# Access Compliance Report

## Public Rights-of-Way

### (Curb Ramps)

Intersection ID: 9514	Main Street: TERRA_COTTA_DR	Cross Street: MOODY_RD	Location: SE
ADA ID: EED1E5FF7E5A	Ramp Type: Perp	Initial Pass/Fail: Fail	Overall Compliance: No
Severity Score: 37.5			
Codes/Mitigation Info/Possible Solution		Field Measurements/Component Compliance

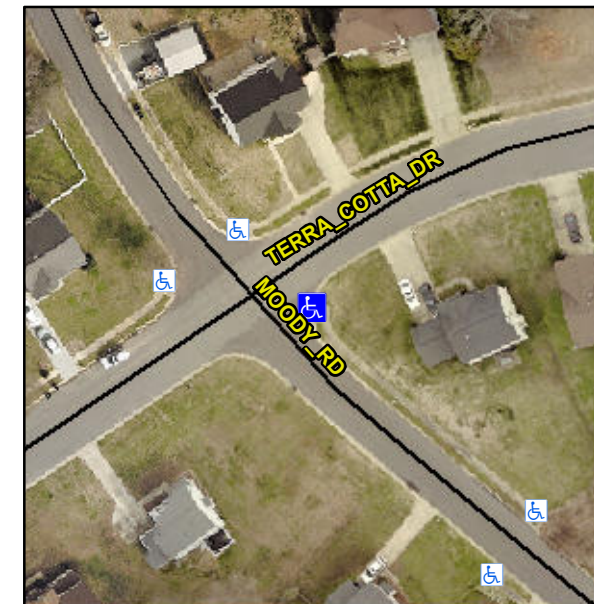
**Not Found, R304.2.2, R304.5.3**

Compliance	Description	Data	Compliance	Description	Data
N/A	Ramp Length (in)	45.0	No	Ramp Slope (%)	8.6
Yes	Ramp Width (in)	48.0	No	Ramp XSlope (%)	7.9
N/A	Flare Type LT	N/A	N/A	Flare Type RT	N/A
N/A	Flare Slope LT (%)	N/A	N/A	Flare Slope RT (%)	N/A
N/A	Flare Traversable LT?	N/A	N/A	Flare Traversable RT?	N/A
N/A	Landing Length (in)	N/A	N/A	DWS Provided?	N/A
N/A	Landing Width (in)	N/A	N/A	DWS Contrast?	N/A
N/A	Landing Slope (%)	N/A	N/A	DWS Length (in)	N/A
N/A	Landing X Slope (%)	N/A	N/A	DWS Full Width?	N/A
N/A	Landing Curb? (Y/N)	N/A	N/A	DWS Offset (in)	N/A
N/A	Shared Landing?	N/A			
N/A	Gutter Ponding?	N/A	N/A	Gutter Slope (%)	N/A
N/A	Gutter Lip Ht (in)	N/A	N/A	Gutter X Slope (%)	N/A
N/A	Painted X Walk1?	No	N/A	Painted X Walk2?	N/A
	X Walk 1 Direction	To NW		X Walk 2 Direction	N/A
N/A	X Walk 1 Width (in)	N/A	N/A	X Walk 2 Width (in)	N/A
	X Walk 1 Slope (%)	10.1		X Walk 2 Slope (%)	N/A
	X Walk 1 X Slope (%)	0.6		X Walk 2 X Slope (%)	N/A

**Remove & Replace Entire Ramp.**
